Comments on #FSP-26-0012 - Planning & Zoning: Final Subdivision Plat

Application Number: #FSP-26-0012
Application Type: Final Subdivision Plat
Date: September 3, 2026
Address: 1832 Rolesville Rd, Rolesville, NC

PHASE 5
KALAS FALLS
1832 ROLESVILLE RD
TOWN OF ROLESVILLE, WAKE COUNTY, NC
CASE NUMBER FSP-26-Qxxx

PHASE 5
FINAL PLAT
ROLESVILLE ROAD, WAKE FOREST, NC 27587
TOWN OF ROLESVILLE - WAKE FOREST TOWNSHIP
WAKE COUNTY- NORTH CAROLINA

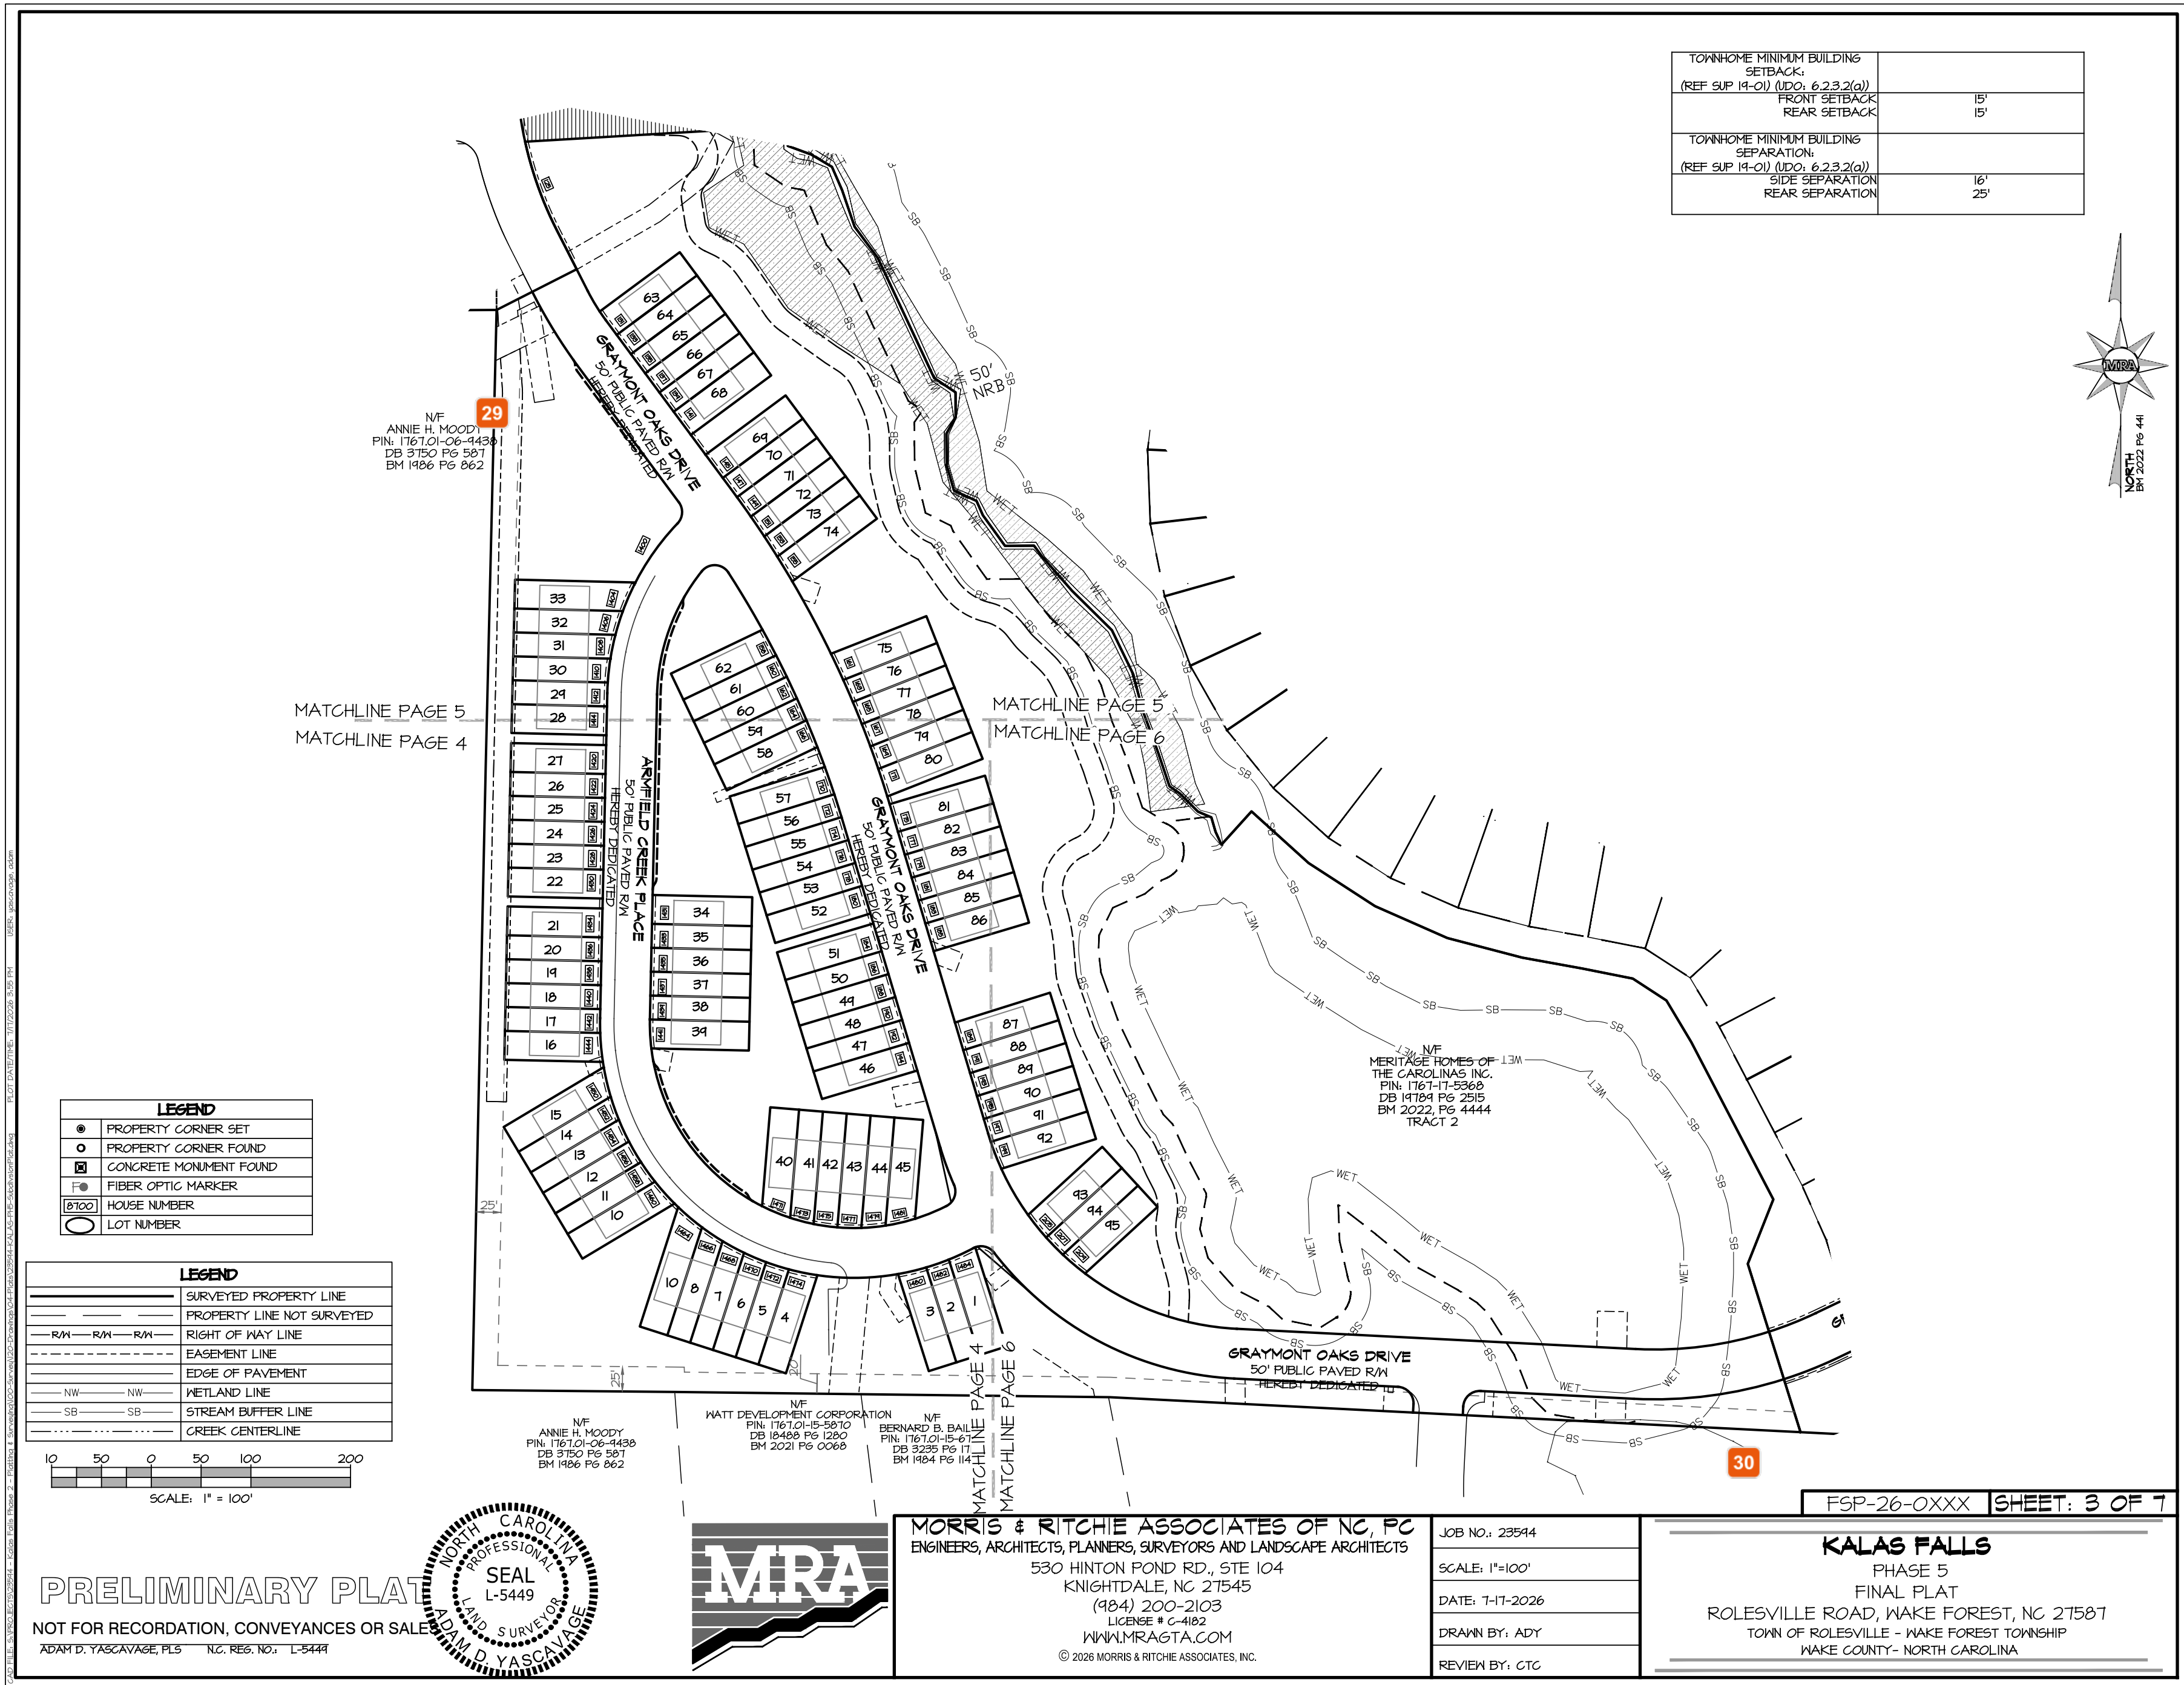
to Note 12 - add a reference to Sheet 2 for Table including Max Impervious Coverage, to tie this note to the actual per lot info.

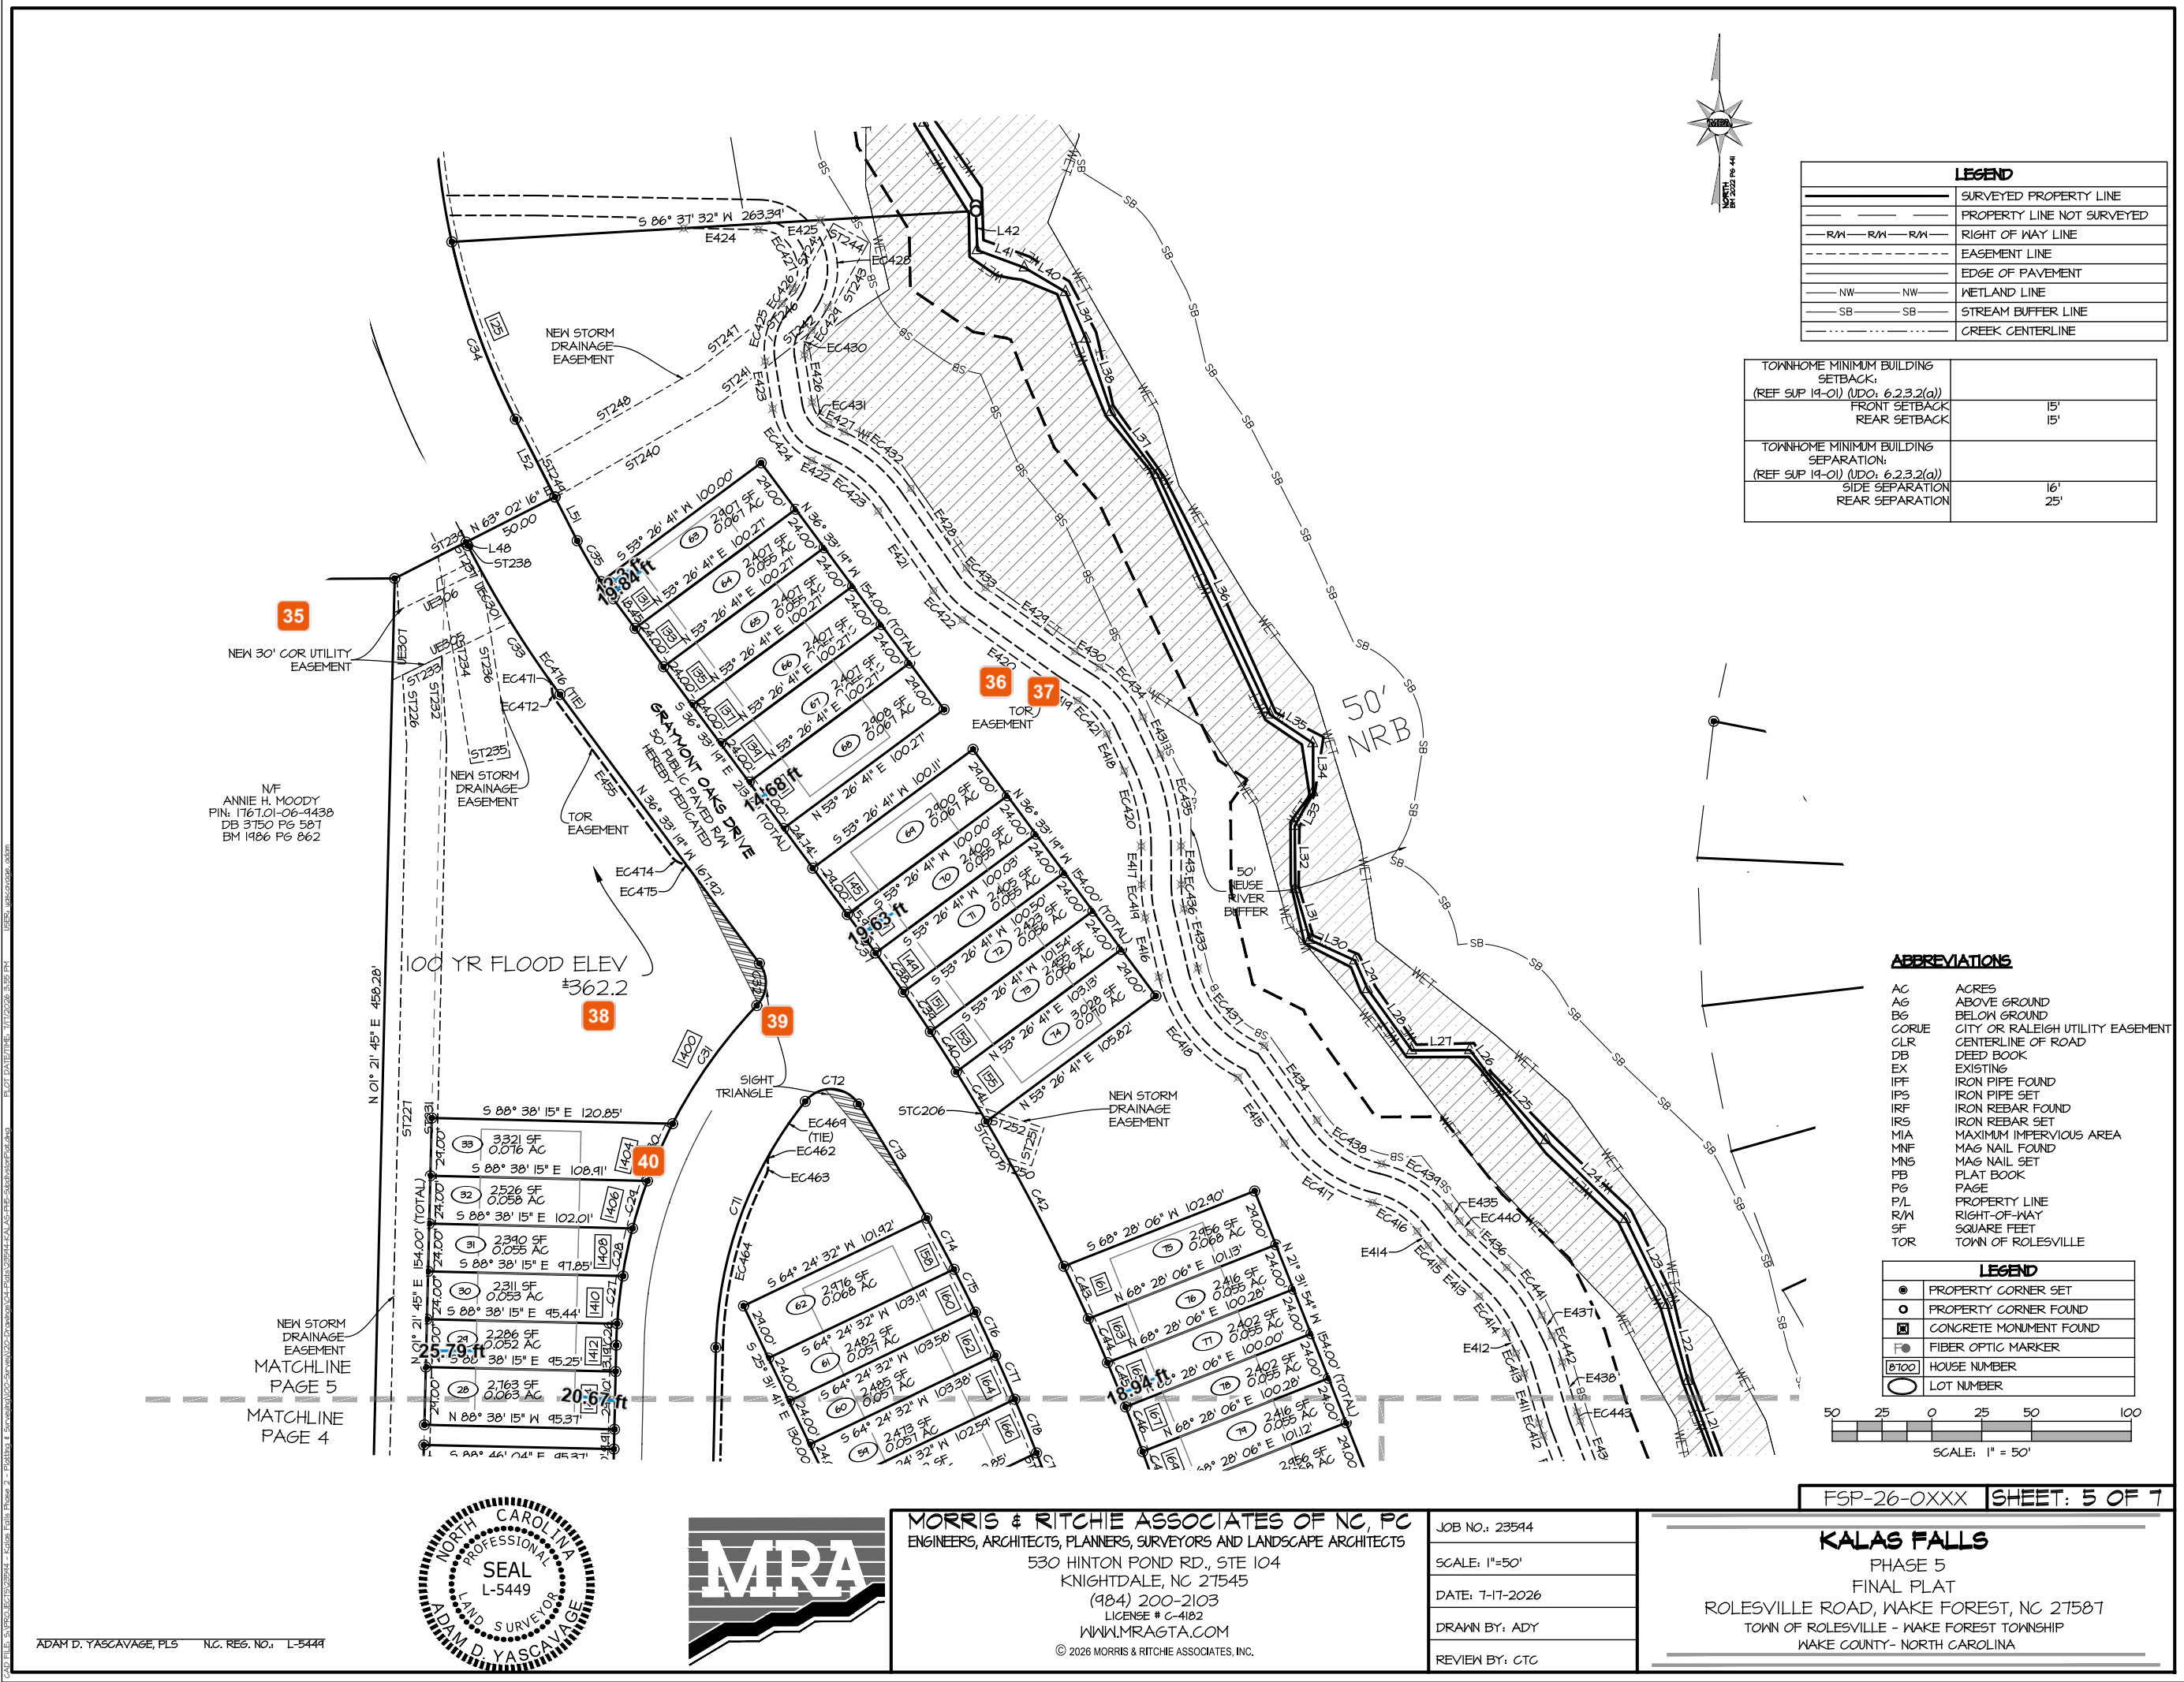
29 Jacqueline Thompson
Text conflict - please adjust label for legibility.

30 Michele Raby
Please mark what each page covers. Is page 3 the overall site plan? If so, please show sidewalk requirement on both sides of the street per UDO Section 6.2.

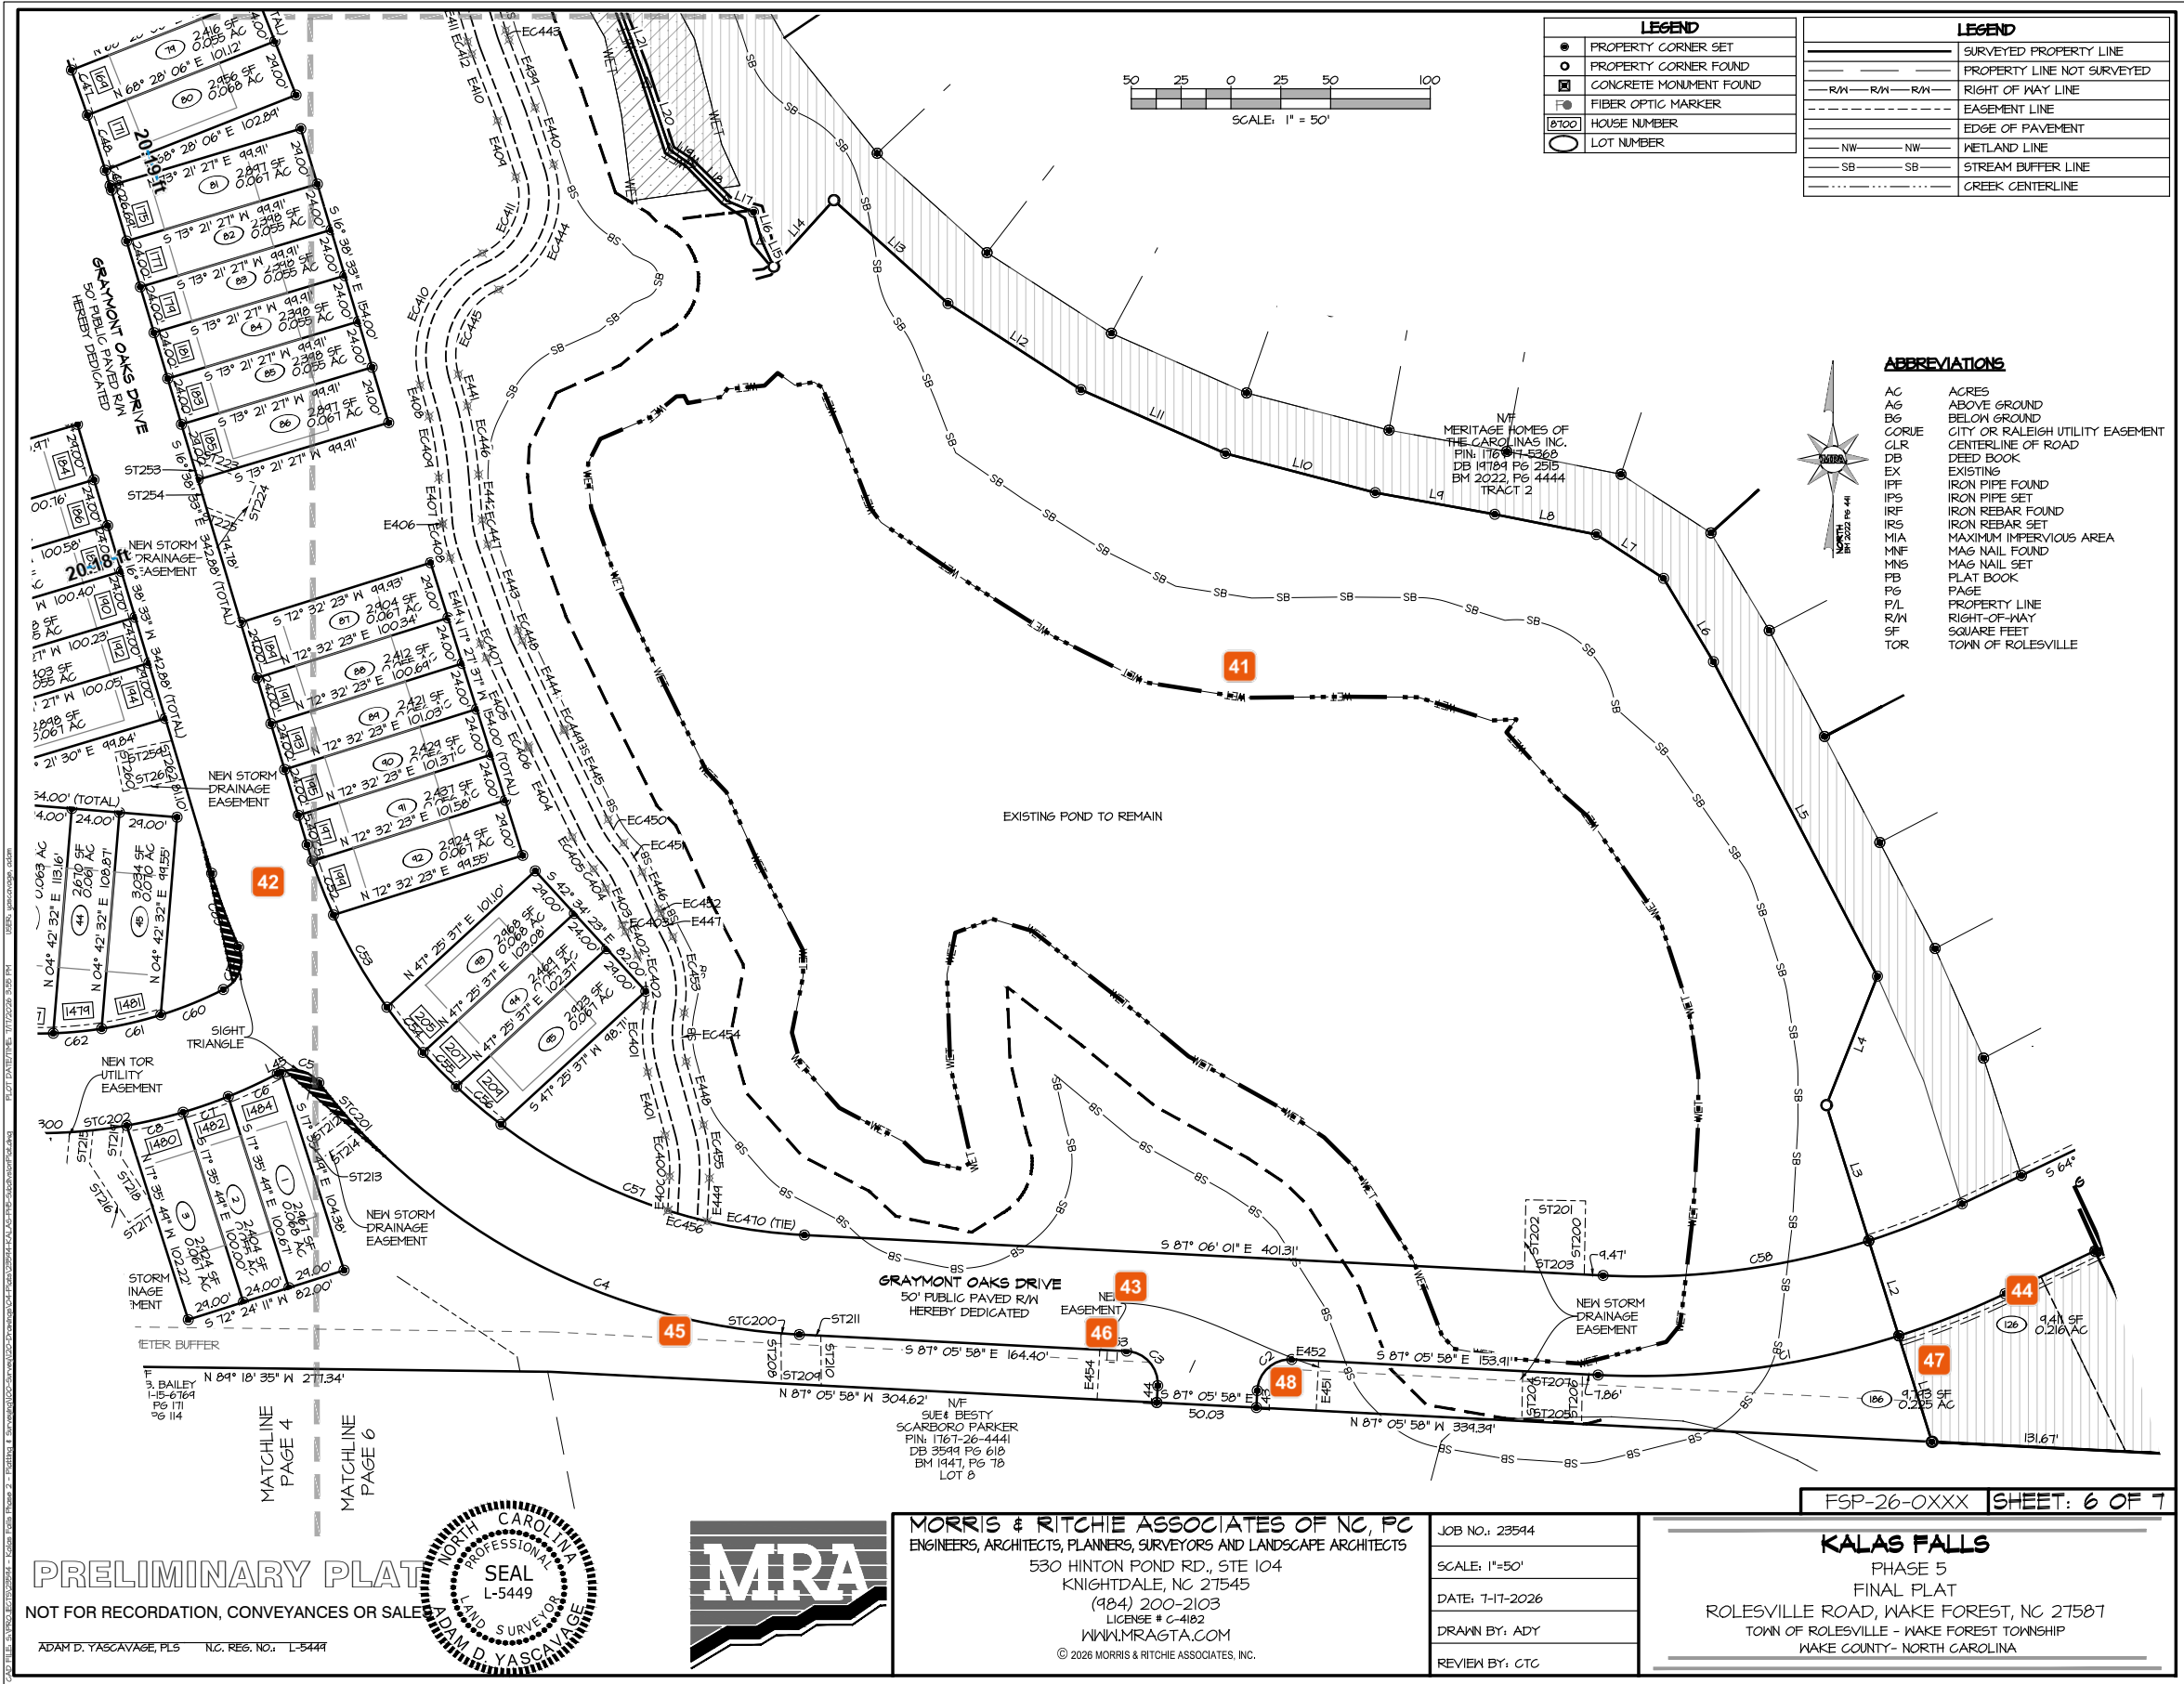
This block/symbol is not in the legend. Please either label, add to legend, or remove if not needed.

Please review the entire plat for overlapping and illegible text. There are several locations where text overlaps text, or text overlaps linework that makes it difficult to clearly read.

This is actually a 30' City of Raleigh Sanitary Sewer Easement, not a TOR utility easement.

35 Tim Beasley
Please rename callout to City of Raleigh Sanitary Sewer Easement

36 Michael Elabarger
IF this is a Proposed easement, meaning New and not recorded already, then phrase as "NEW" or "PROposed" - you seem to be going with "NEW" on other easements observed...

37 Eddie Henderson
Please revise to say TOR Greenway Easement. Also indicate width
